**DEFENSE NUCLEAR FACILITIES
SAFETY BOARD**

Staff Report

September 25, 2017

SUBJECT: Transuranic Waste Facility Documented Safety Analysis Development Review

Figure B-1. *Empirical vs. Predicted Heat Flux Values (Source: SFPE Handbook, 3rd Edition, 2002 [B-3])*

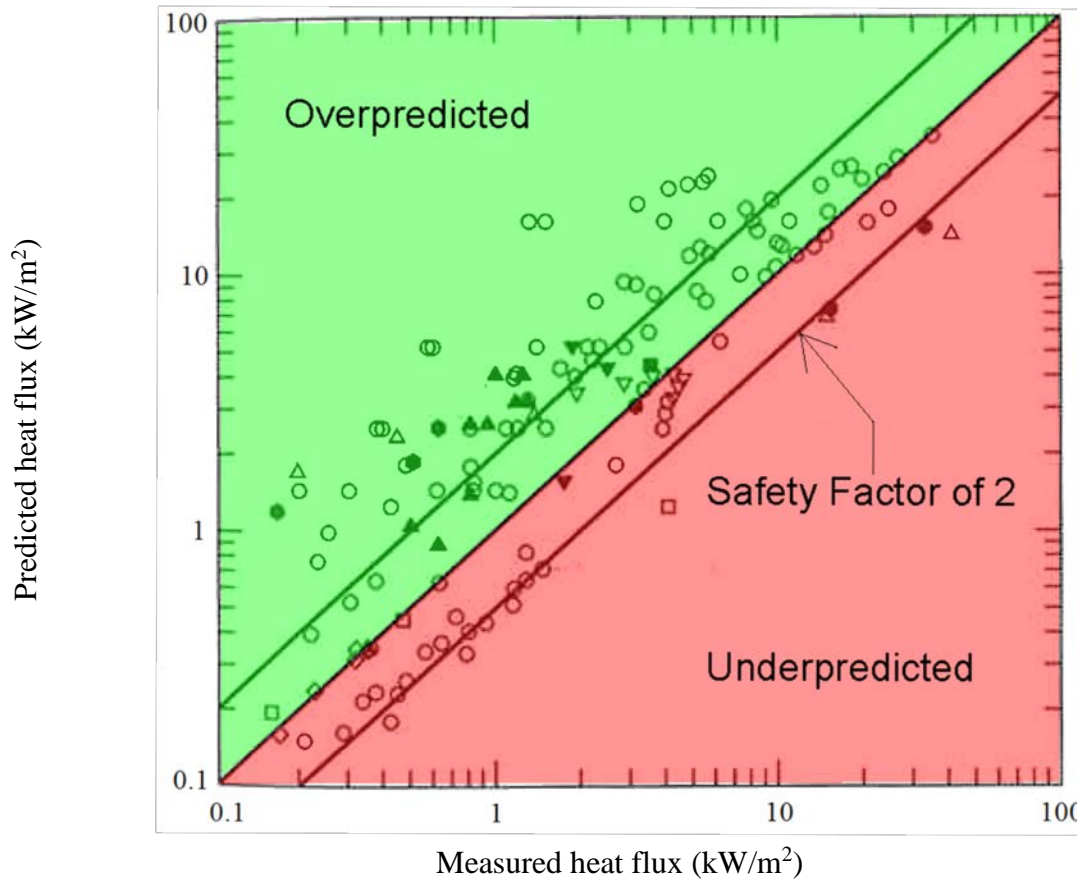
Figure B-1 shows the predicted and measured heat fluxes from the Mudan and Croce method. Note that without the safety factor, there are a number of data points where the Mudan and Croce method under predicts the radiant heat flux. Using a safety factor of 2 ensures that nearly all of the data points fall in the over predicted region. The LANL calculation [B-2] does not appear to incorporate an explicit safety factor as suggested by the method, and no discussion of this safety factor is provided in the calculation.

Figure C-12. CFAST Results - Maximum column temperatures with varying fire ventilation

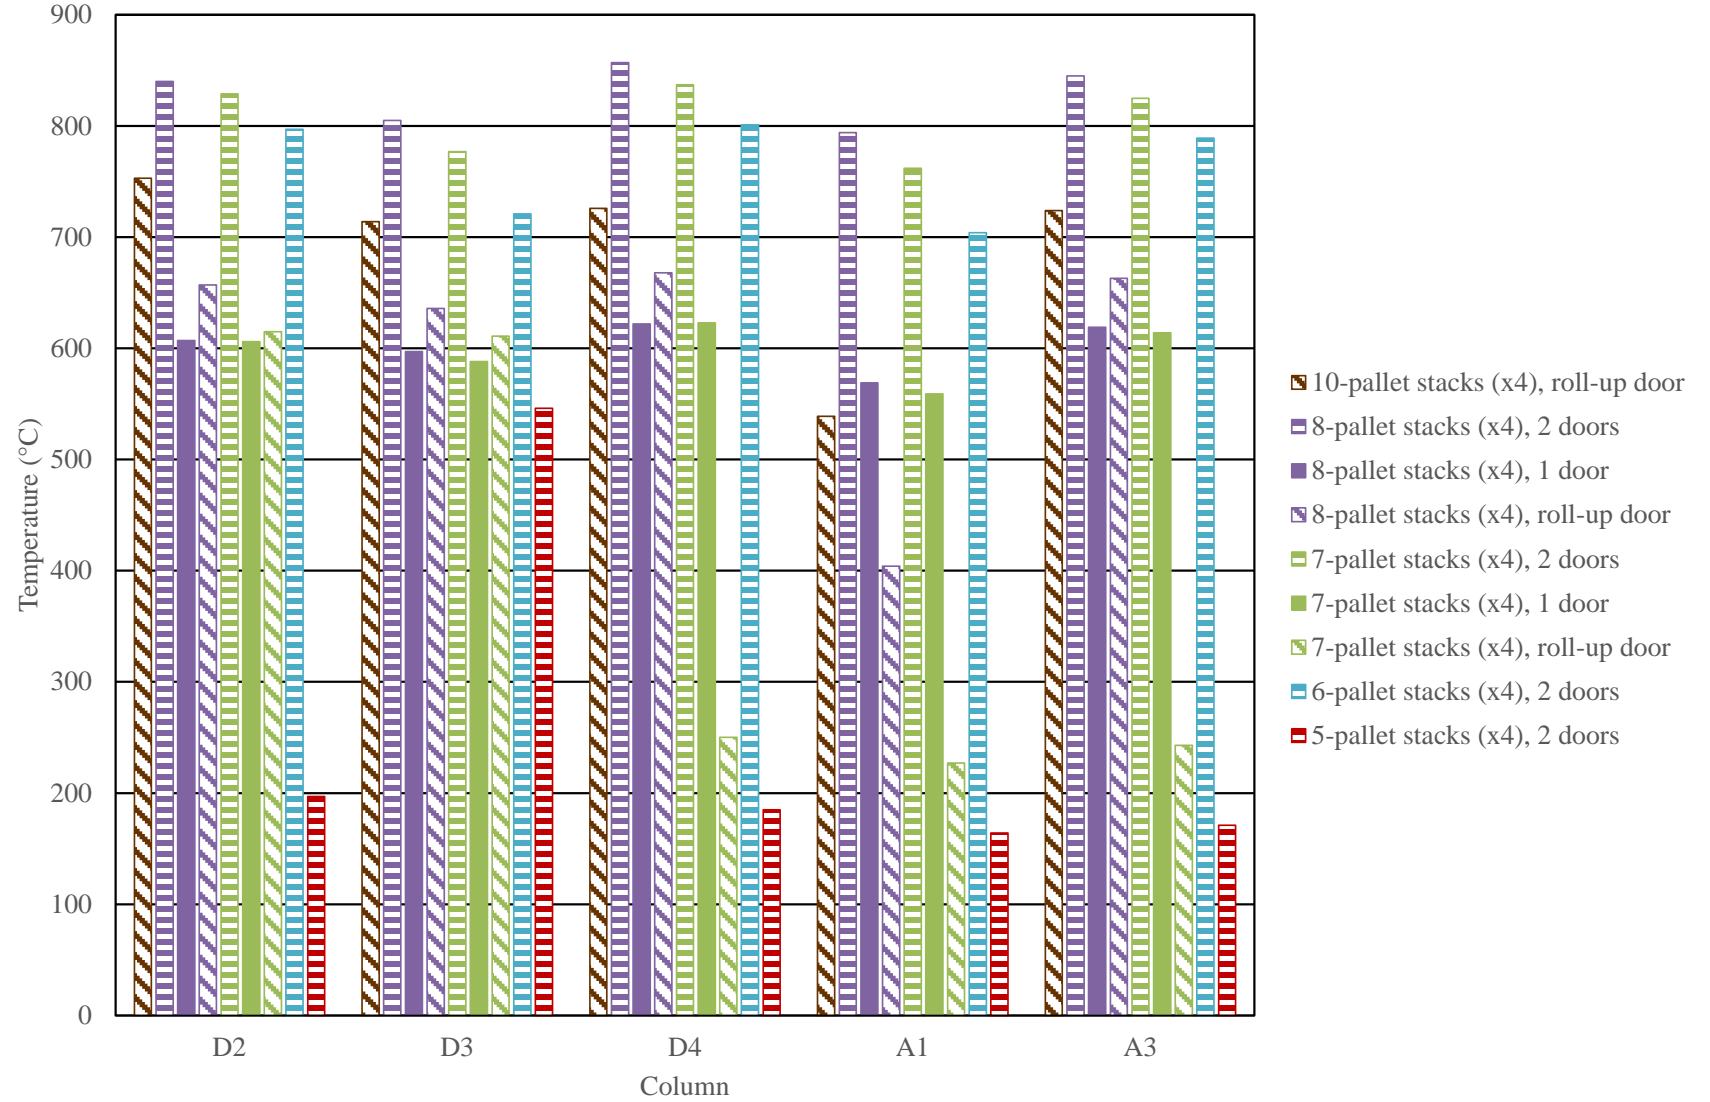
Figure C-12 shows the maximum column temperatures reached under the varying ventilation conditions considered in this evaluation. As seen in the figure, only scenarios with two personnel doors open consistently result in column temperatures well above 700 °C (1290 °F), and then only with six-high pallet stacks or more. The only scenarios where the maximum temperature of column A1 is above 700 °C (1290 °F) are the six-, seven-, and eight-pallet stack scenarios with two personnel doors open. This is the only column considered in the model that does not have an adjacent pallet stack fire, and is the column most remote from the fires. When the combustible load with two doors open is reduced to five-pallet stacks, only the initial pallet stacks burn and the maximum column temperatures at those stacks only get to about 550 °C (1,022 °F).

Figure C-13. CFAST Results - Maximum column temperatures with two personnel doors open

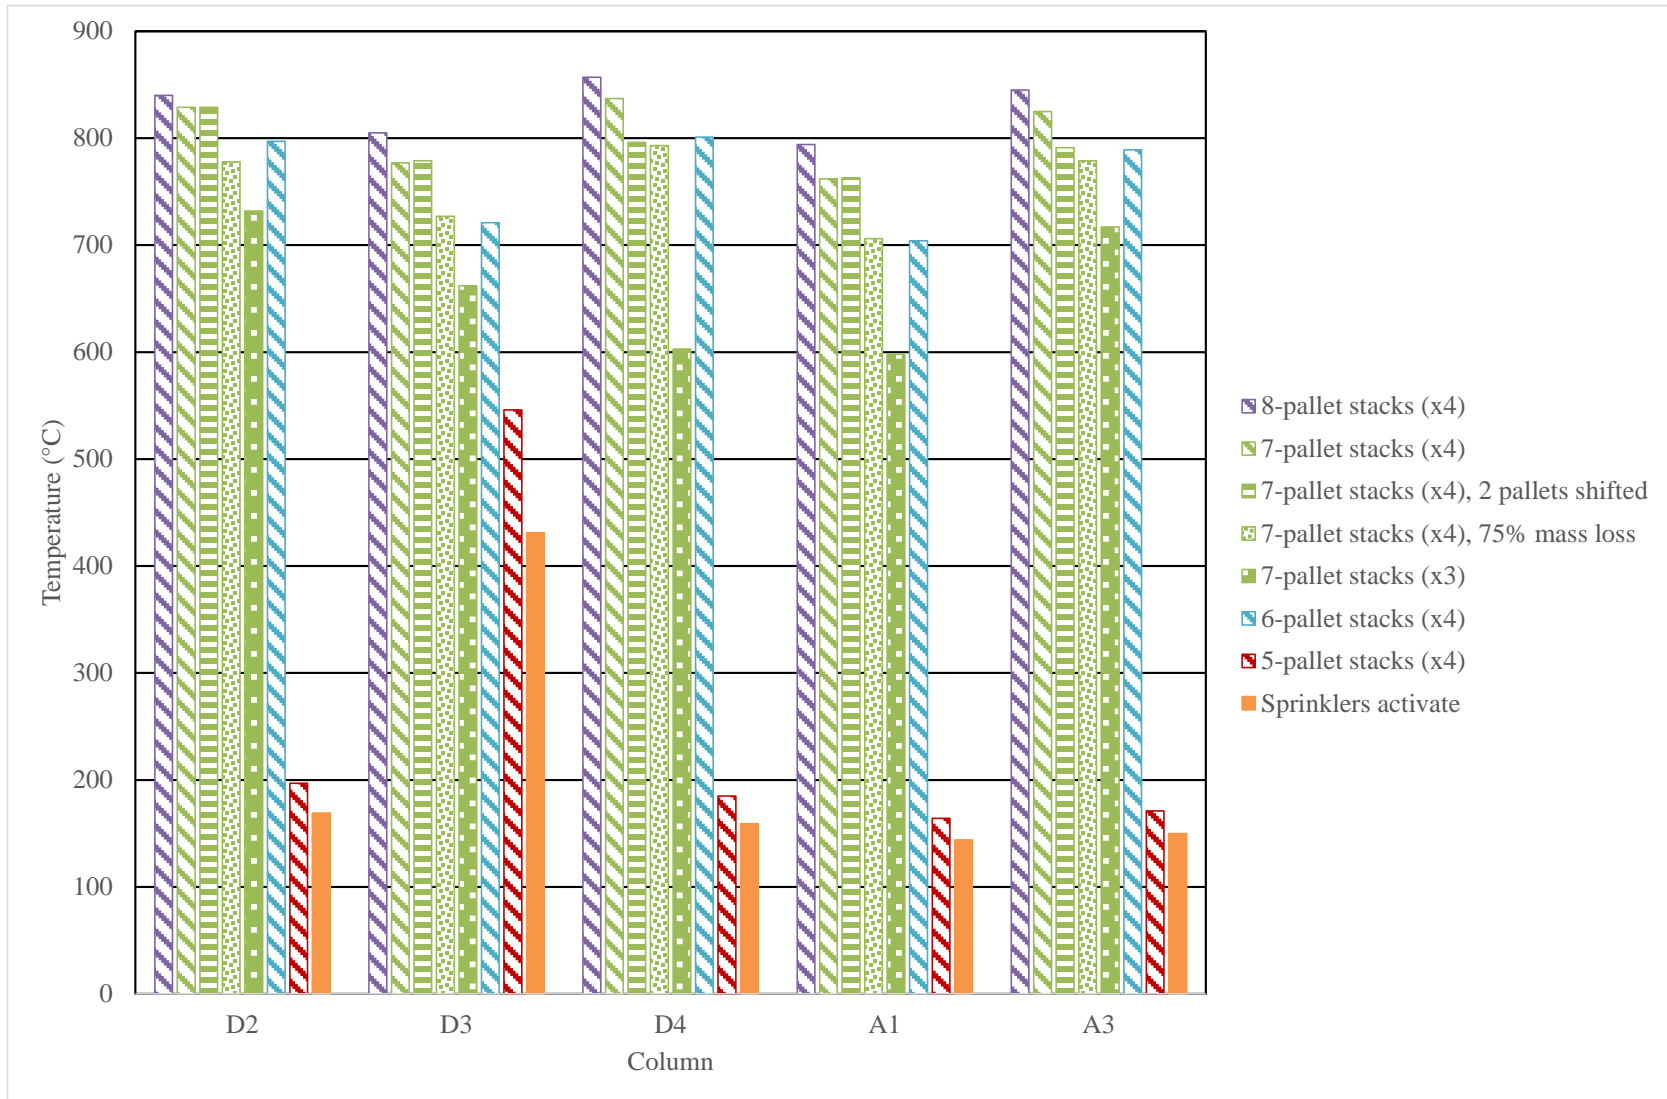
Figure C-13 shows the results of scenario variation with two personnel doors open. The four pallet stack scenarios with five-, six-, seven-, and eight-pallets each are repeated for clarity in this figure. One additional scenario considers only three stacks of seven pallets each, where the pallet stack at column D4 is not included. In this scenario the other two pallet stacks still ignite, but the column temperatures are significantly lower than when four stacks are included. Excluding column D4, the average reduction in column temperature with three stacks is 18 percent. In the three-stack scenario, only two columns are above 700 °C (1290 °F).
